City of West Linn
PRE-APPLICATION CONFERENCE MEETING
SUMMARY NOTES
March 15, 2012

SUBJECT: Class I Design Review and Class II Variances for changes to McDonald's site at 2100 Eighth Court to accommodate an additional drive through/take out lane. Changes to landscaping, parking spaces and the trash enclosure are also proposed.

Preap-PA-12-06 McDonalds summary

1 PROPOSED SITE PLAN
SP1 1" = 30'-0"

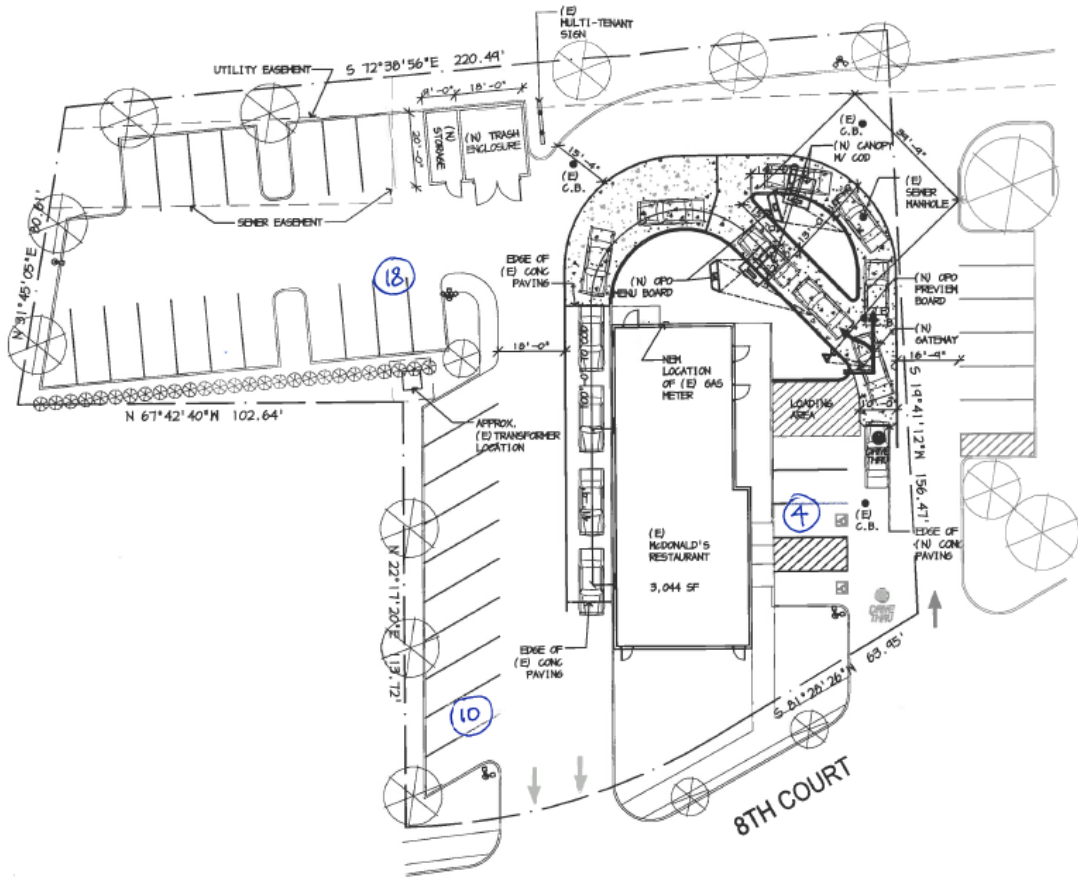
The Community Development Code (CDC) has established minimum widths for driveway lanes and parking lot maneuvering. CDC section 46.150(F) requires a minimum width of 23 feet to accommodate cars backing out of a 90 degree angle parking space. The width, as first proposed by McDonald's, is only 16 feet nine inches which does not meet the standard. Drive through/take out lanes must be at least 12 feet wide per CDC 48.040(A)(4). The applicant proposes one of the lanes is proposed to be 10 feet wide and would not meet the standard.

The applicant submitted a plan at the pre-app which improved on the previously submitted plan by increasing the space between the drive-through lanes to 23 feet, but another plan with both drive-through lanes at 12 feet (one is still shown at 10) is necessary as part of the application for it to meet the provisions of Chapter 46.

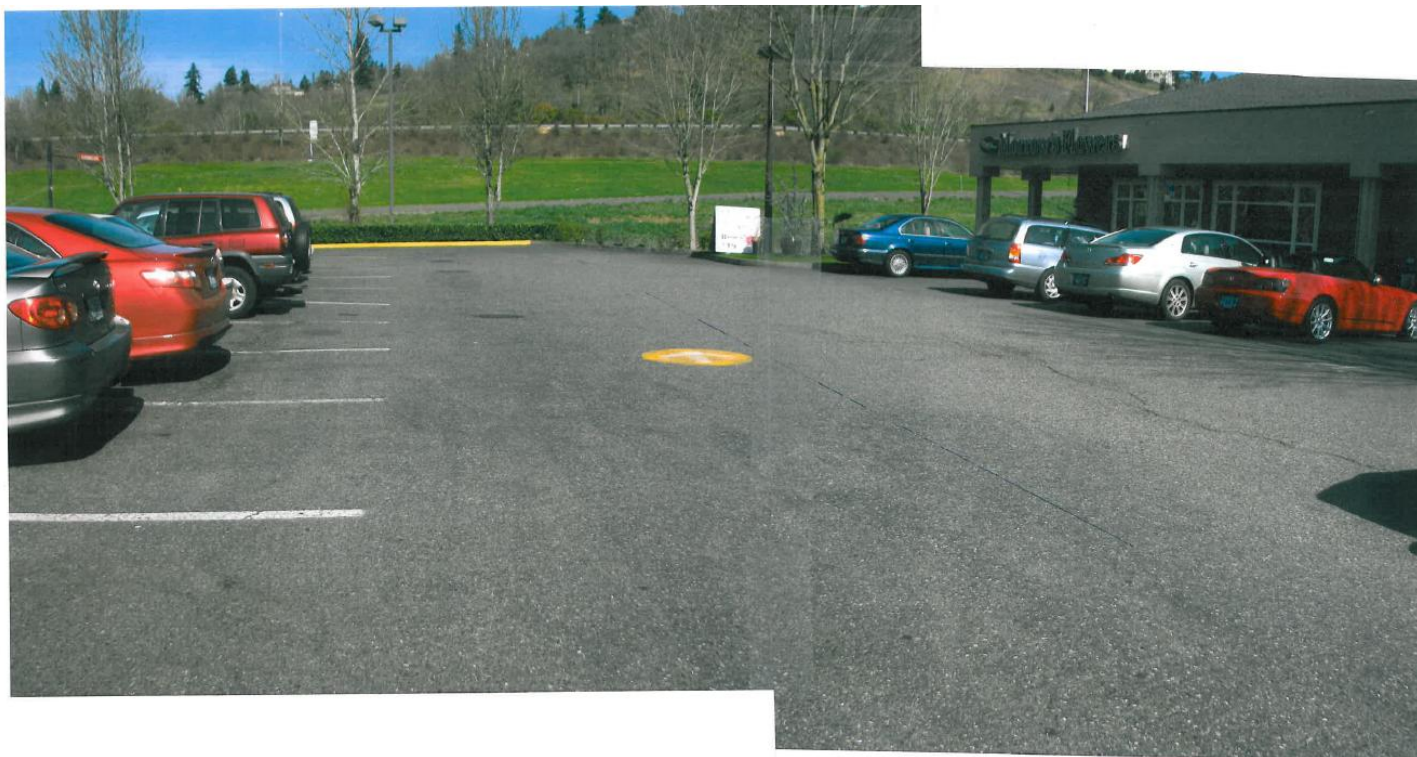
Staff visited the site and observed cars backing out of the retail center's parking spaces. Most of the mid-sized cars (12-14 feet long) went beyond the 16 foot nine-inch mark in the original proposal. Staff can support a proposal where both required minimums (23 foot parking aisle, 12 foot drive-through lanes) are met but may want to participate in a field check of this area before the applicant submits the application to be sure to be sure these dimensions can be achieved.
